Duane Arnold Energy Center
Docket No. 50-331
Renewed Op. License No. DPR-49

NextEra Energy Duane Arnold, LLC's Final Compliance with EA-12-051 Order to Modify Licenses with Regard to Reliable Spent Fuel Pool Instrumentation

NextEra Energy Duane Arnold, LLC's Final Compliance with EA-12-051 Order
Modifying Licenses with Regard to Reliable Spent Fuel Pool Instrumentation

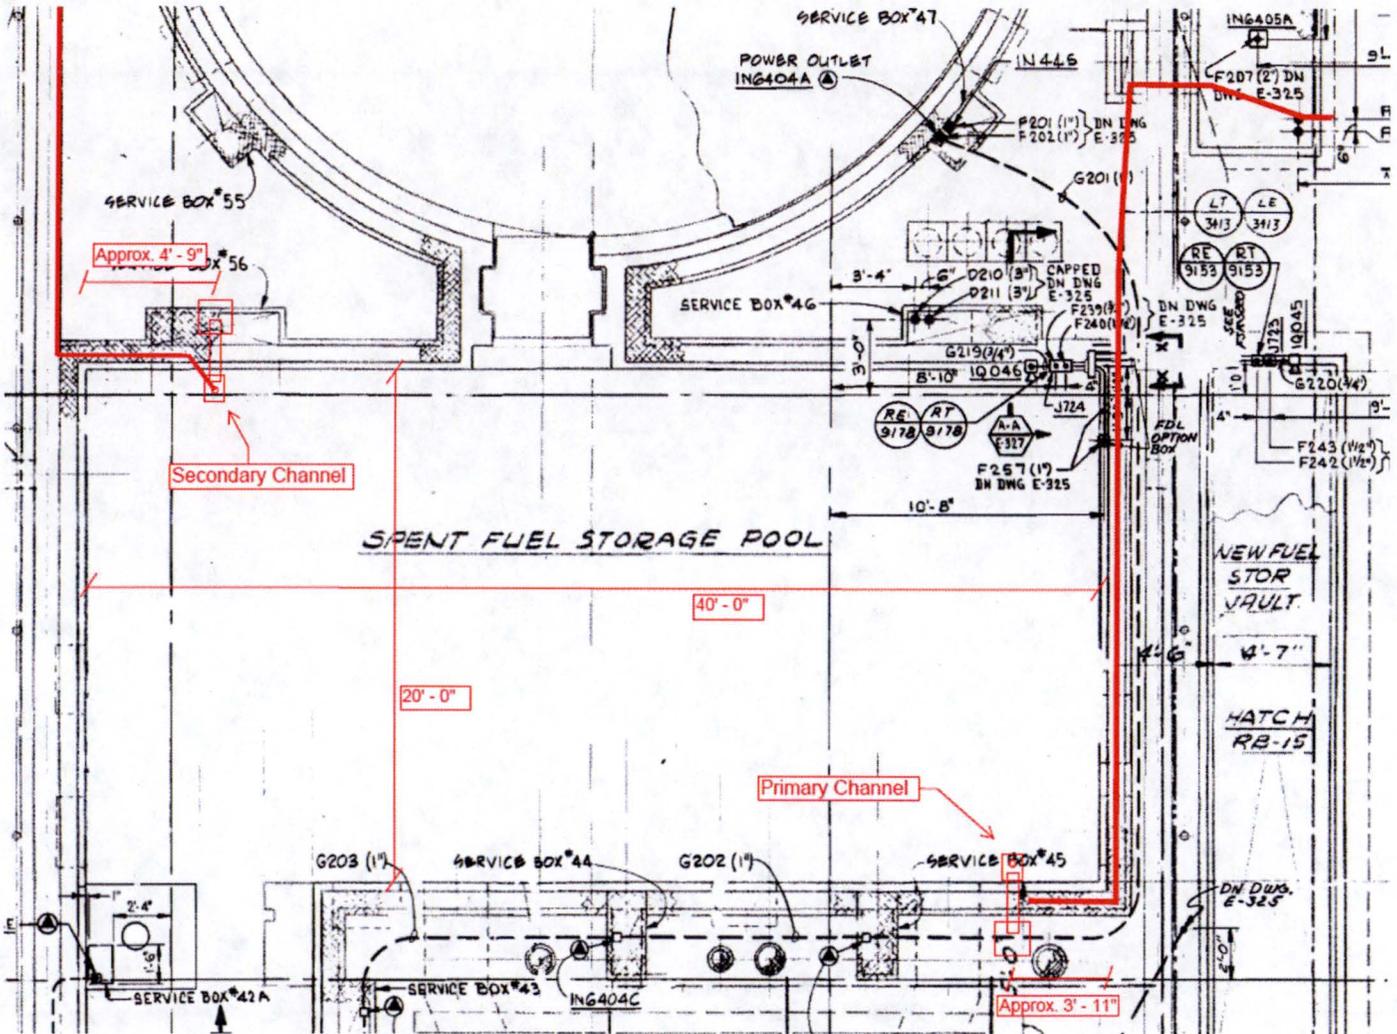
DAEC RAI 1

Please modify the marked-up plant drawing of the plan view (in Section XVIII, Page 10 of 10) of the SFP area, to depict the SFP inside dimensions, the planned locations/ placement of the primary and back-up SFP level sensors, and the proposed routing of the cables that will extend from the sensors toward the location of the local electronics cabinets and read-out/display devices in the main control room or alternate accessible location.

See the attached marked up drawing of BECH-E327 depicting inside dimensions of the Spent Fuel Pool (SFP), the locations of the Primary and Secondary SFP Level sensors, and the independent routes of the cables on the refueling floor. SFP level sensors have been located in opposite corners of the pool and cable routes have been kept independent and separated by at least the shortest length of the pool (20'-0") per the NEI 12-02 guidance.

Control Room

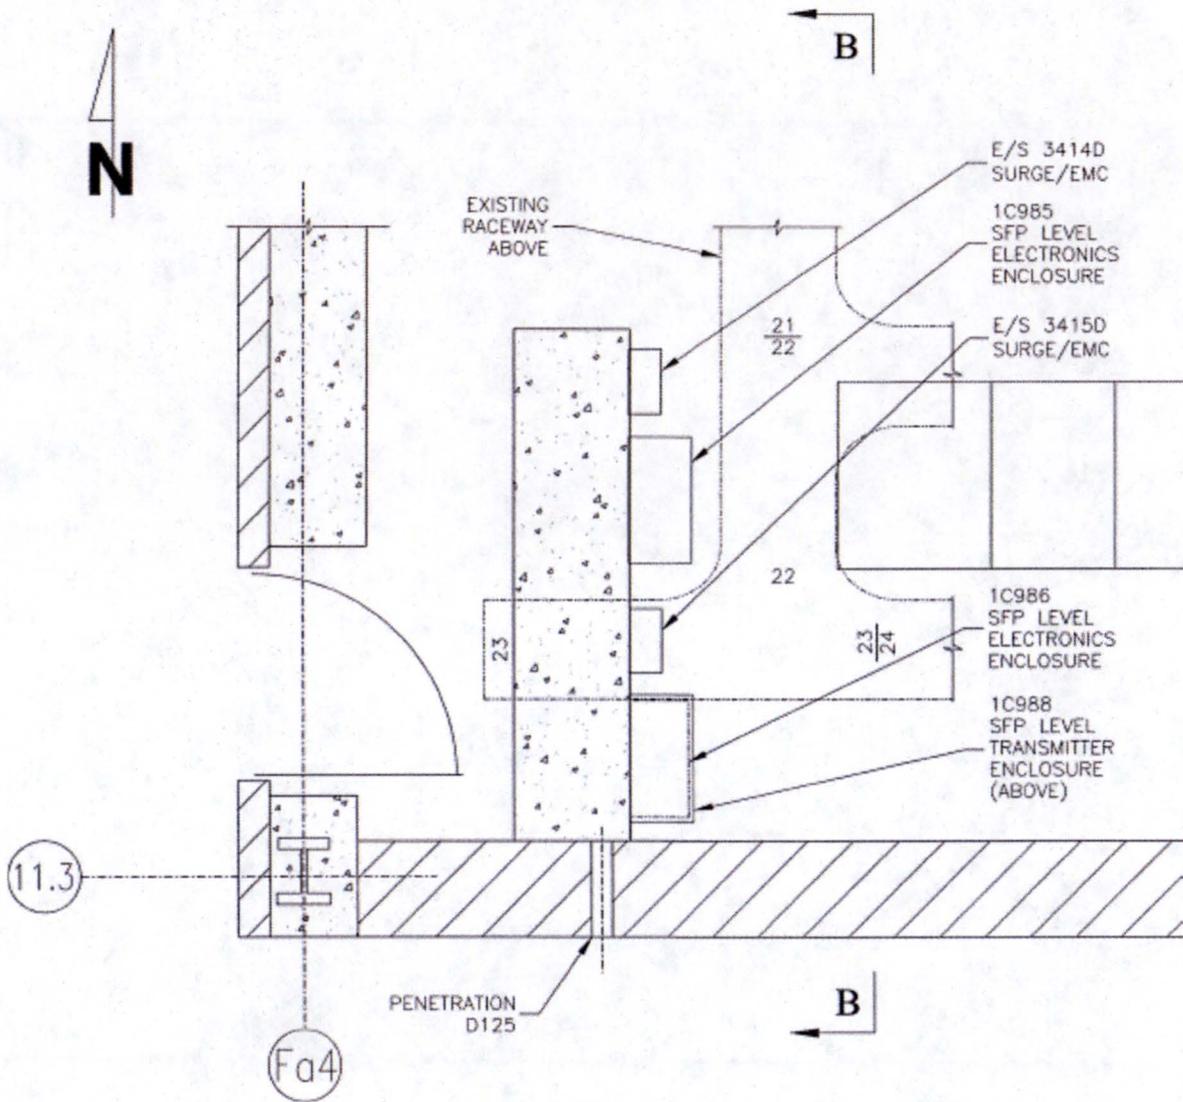
DAEC RAI 11

- a) The specific location for each of the primary and backup instrument channel displays.
- b) For any displays located outside the MCR, describe the evaluation used to validate the display location can be accessed without unreasonable delay following a BDB event. Include the time available for personnel to access the display as credited in the evaluation, as well as the actual time (e.g., based on walk-throughs) that it will take for personnel to access the display. Additionally, include a description of the radiological and environmental conditions on the paths personnel might take. Describe whether the display location remains habitable for radiological, heat and humidity, and other environmental conditions following a BDB event. Describe whether personnel are continuously stationed at the display or monitor the display periodically.

Primary and backup level instrument displays are located in the Southwest corner of the Control Room behind the control board panels. The indicators are located on the 1C985 and 1C986 electronics enclosures in the Control Room. Personnel will be stationed in the Control Room during a BDBEE such that the displays are in a habitable environment, will be readily accessible and will be monitored periodically.

See the attached drawings showing exact locations:
